From: Byers, Harris <Harris.Byers@stantec.com>
Sent: Thursday, April 18, 2019 1:13 PM
To: Choi, Christopher; April Kroner; Paul Braun; kmcdaniel@manitowoc.org
Cc: Beggs, Tauren R - DNR; Ramanauskas, Peter; Cull, Whitney
Subject: Second Round of Sampling at Mirro
Attachments: Figures 1-4 - Proposed Sample Locations.pdf

From the email exchanges earlier this week, below is a description of the anticipated scope of work for the second round of sampling at the Mirro facility in Manitowoc. Figures illustrating proposed sampling locations are attached. COCs and sampling strategy presented in Table 1 and Table 2 of the Workplan remain valid. Depending on groundwater quality (data expected April 24), this scope may be further adjusted to maximize project benefit in the field. Will let you know of any substantial changes.

Figure No. **4**
 Title **Figure 4. Proposed Sample Locations**

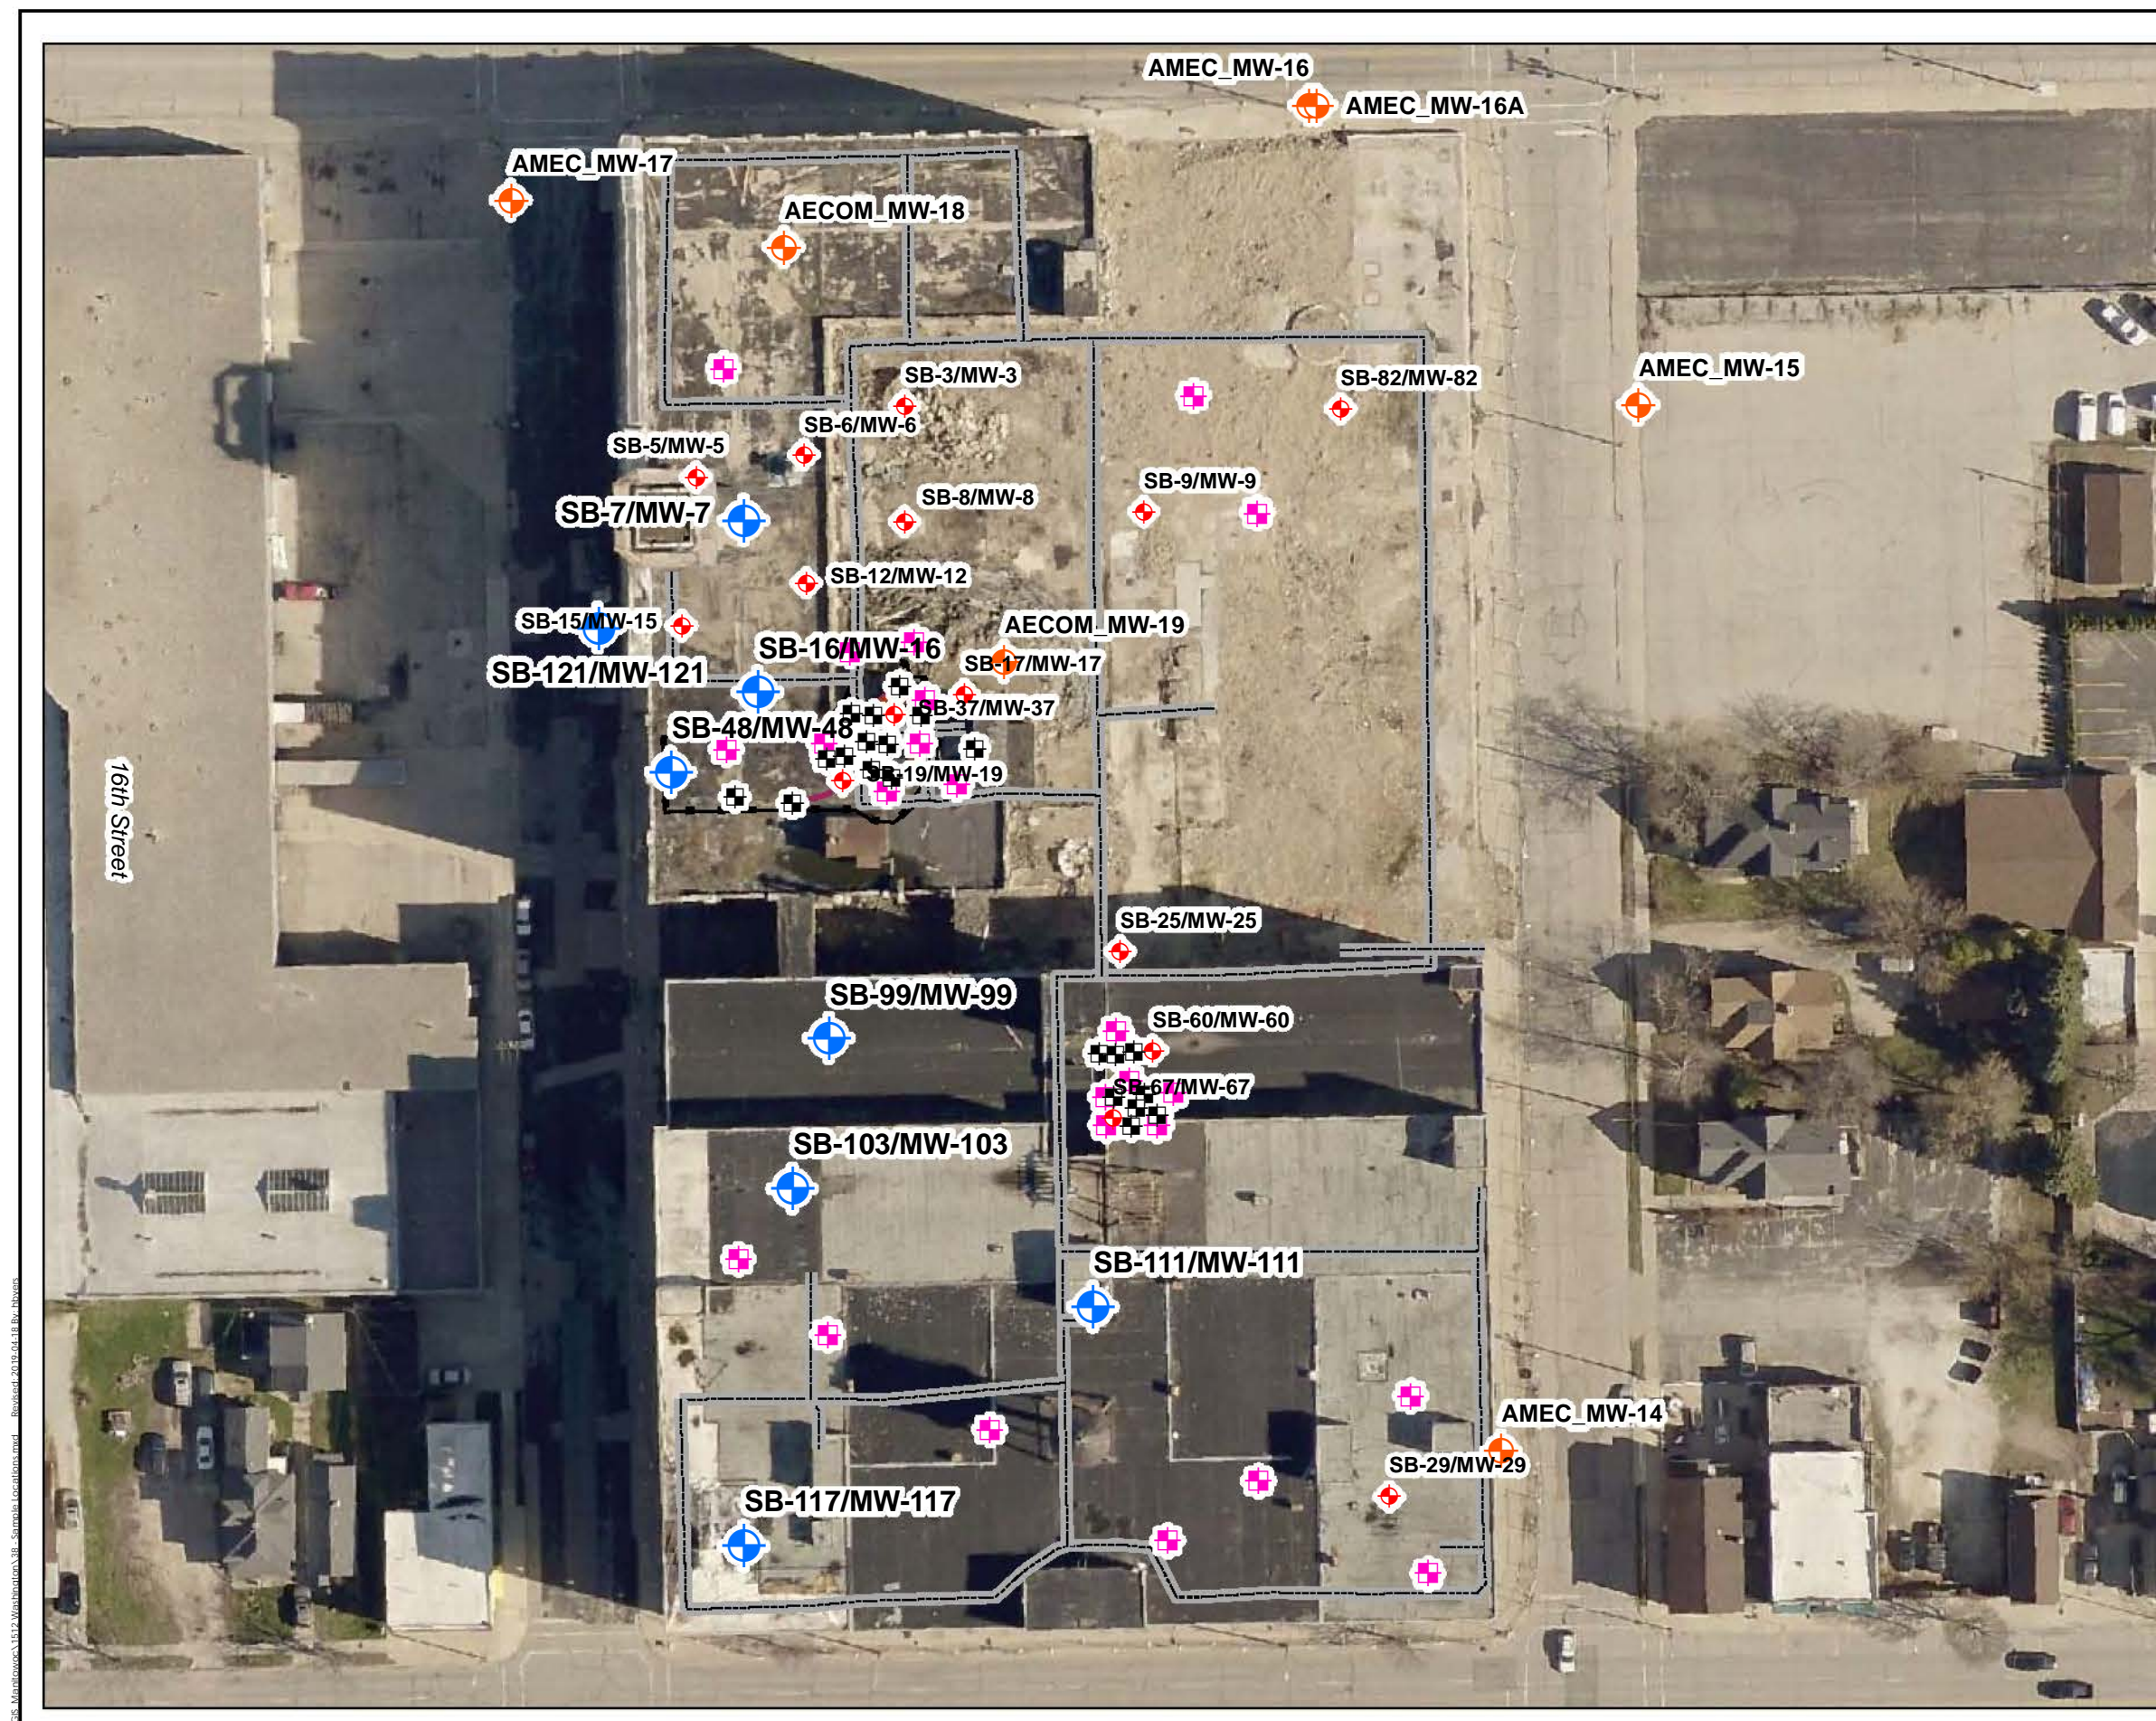
- Sample sentinel wells (AMEC_MW-17; AMEC_MW-16; AMEC_MW-15; AMEC_MW-14) for VOC and PAH
- Sample AECOM_MW-18 and AECOM_MW-17 for VOC and PAH and confirm presence/absence of LNAPL

- Time permitting, install SB-99, SB-103, SB-117, and SB-111 and complete as monitoring wells to determine the presence/magnitude of COCs under the southern building, which appears to be upgradient.

Figure No. **1**
 Title **Figure 1. Identified LNAPL and Proposed Sample Locations**
 Client/Project
 City of Manitowoc
 USEPA Brownfield Assessment Grant
 Hazardous Substances
 0 15 30 Feet
 193703931
 Prepared by HLB on 5-22-18

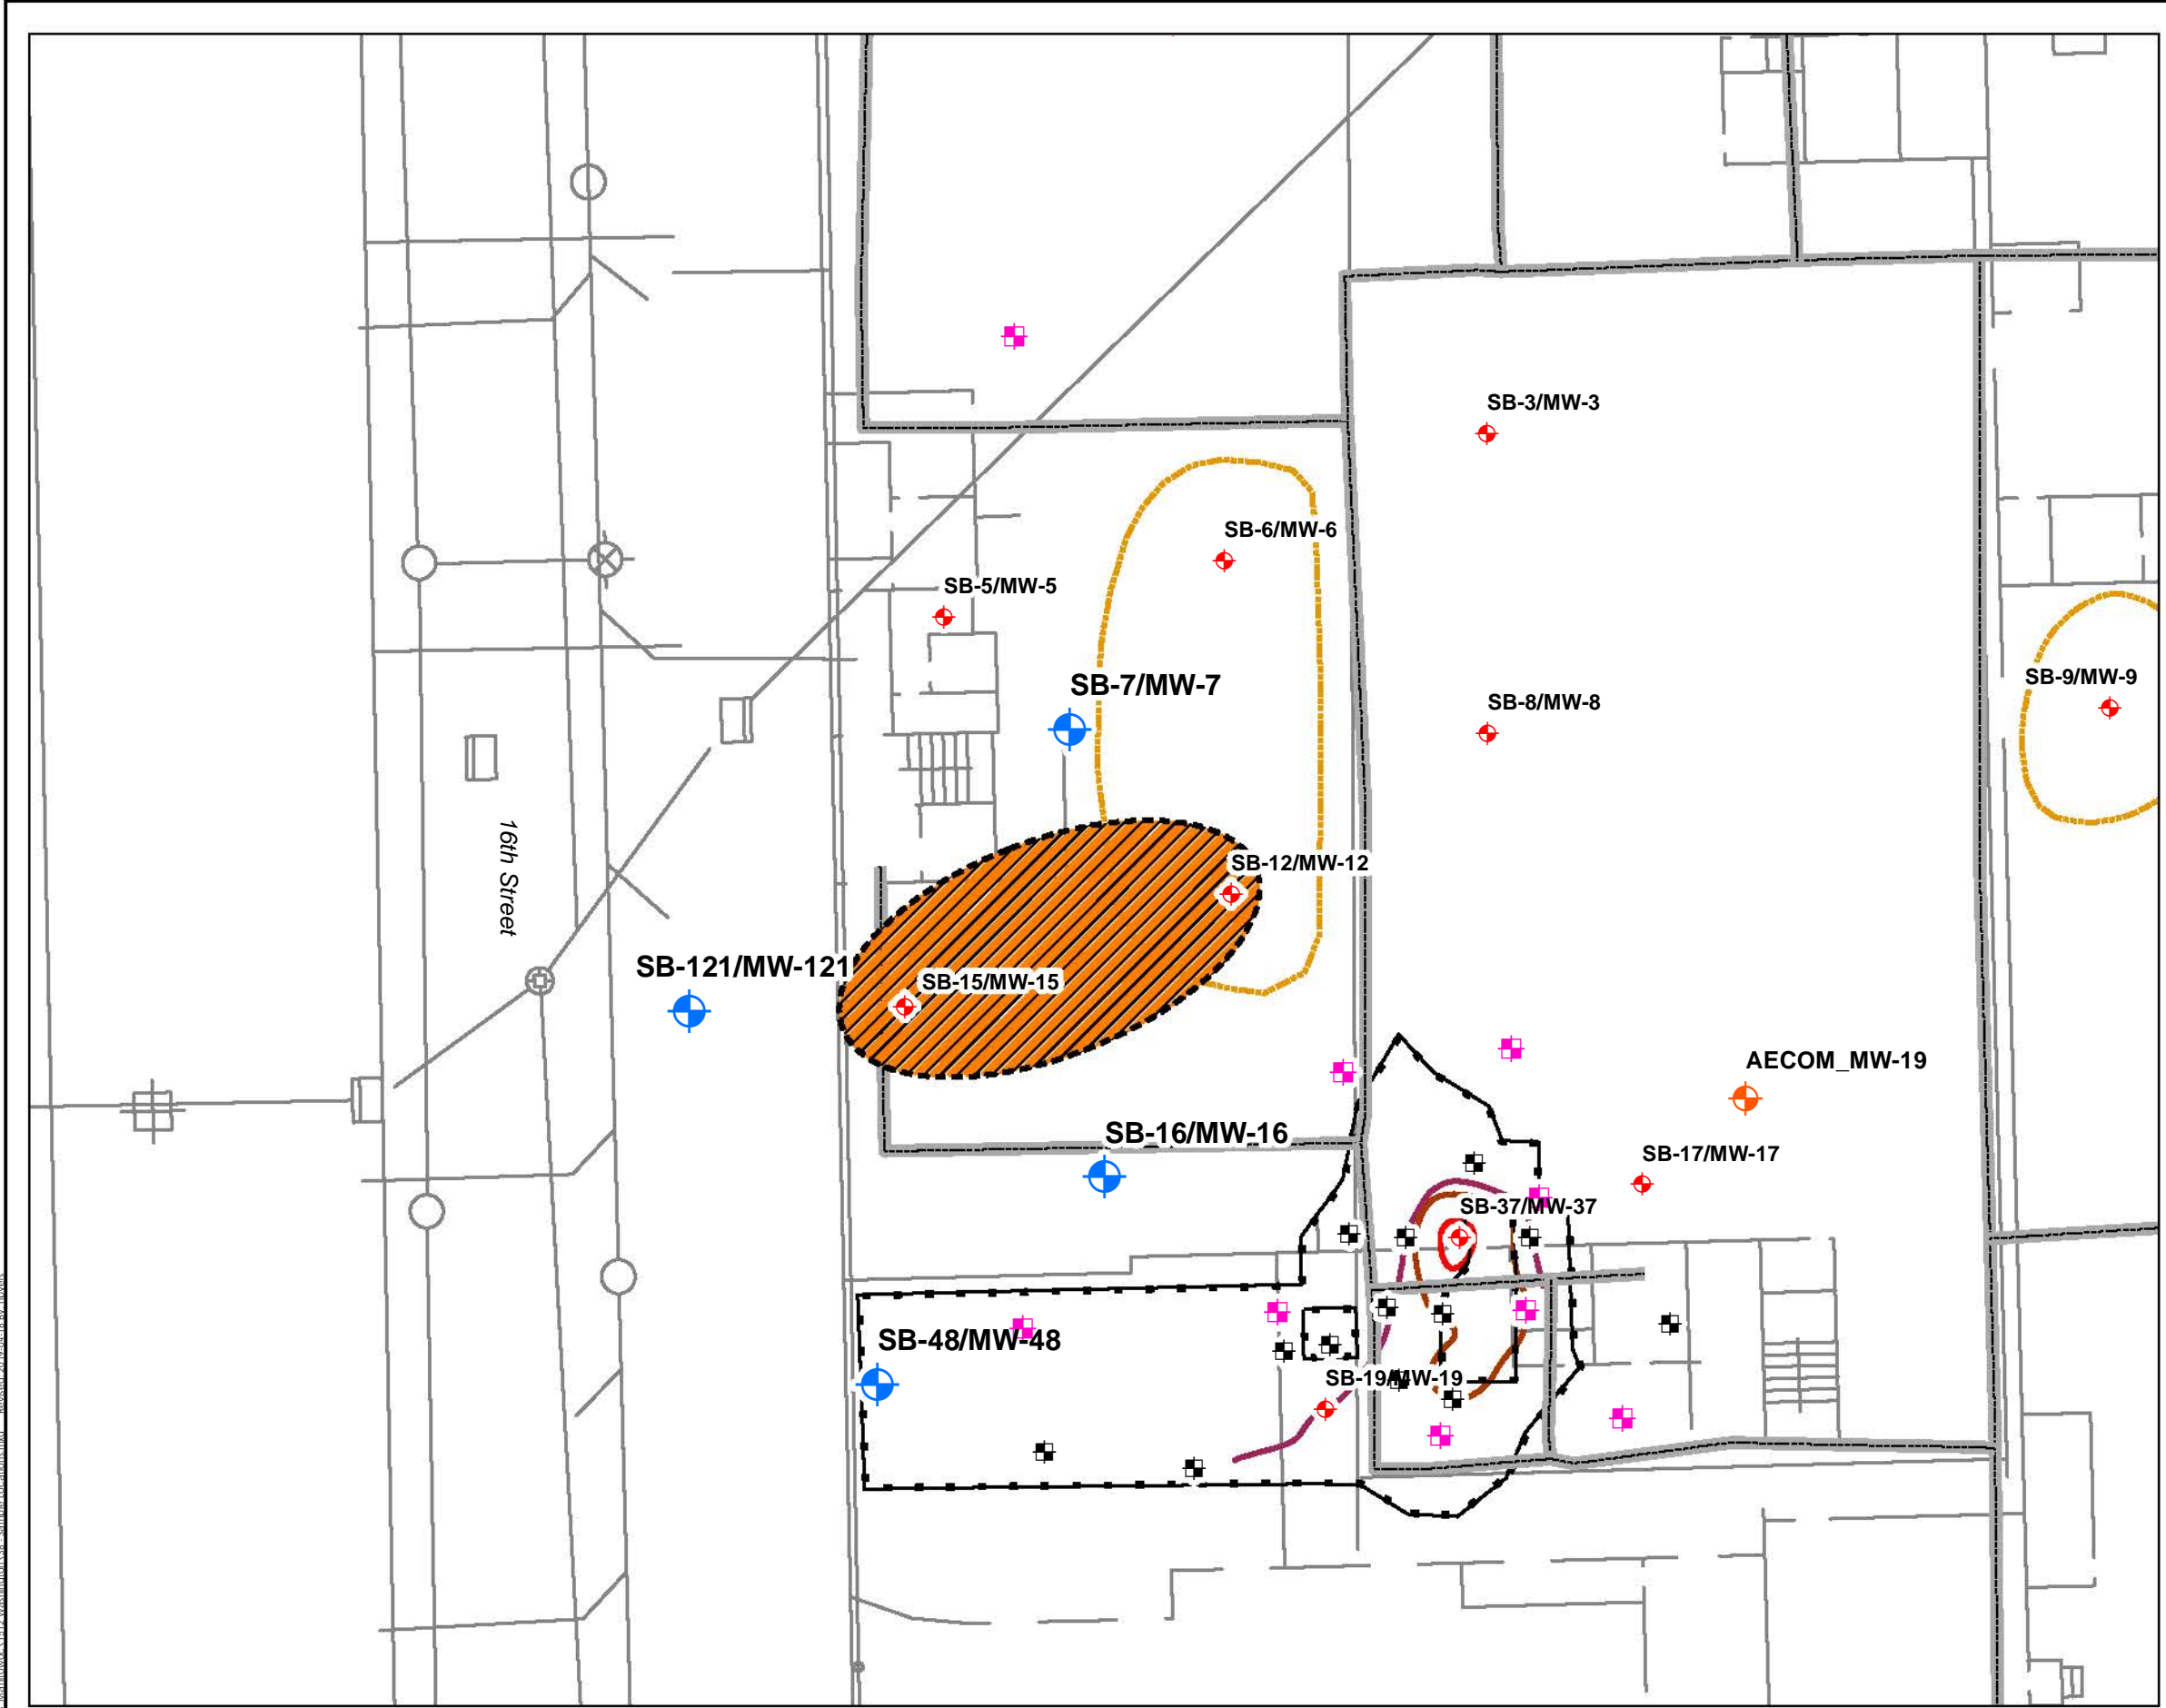
- Install MW-121 to the west of MW-15 in the right-of-way; MW will be completed with flush-mount cover.
- Complete SB-7 as a monitoring well
- Move SB-16 slightly to west and complete as a monitoring well
- Sample LNAPL for fingerprinting source
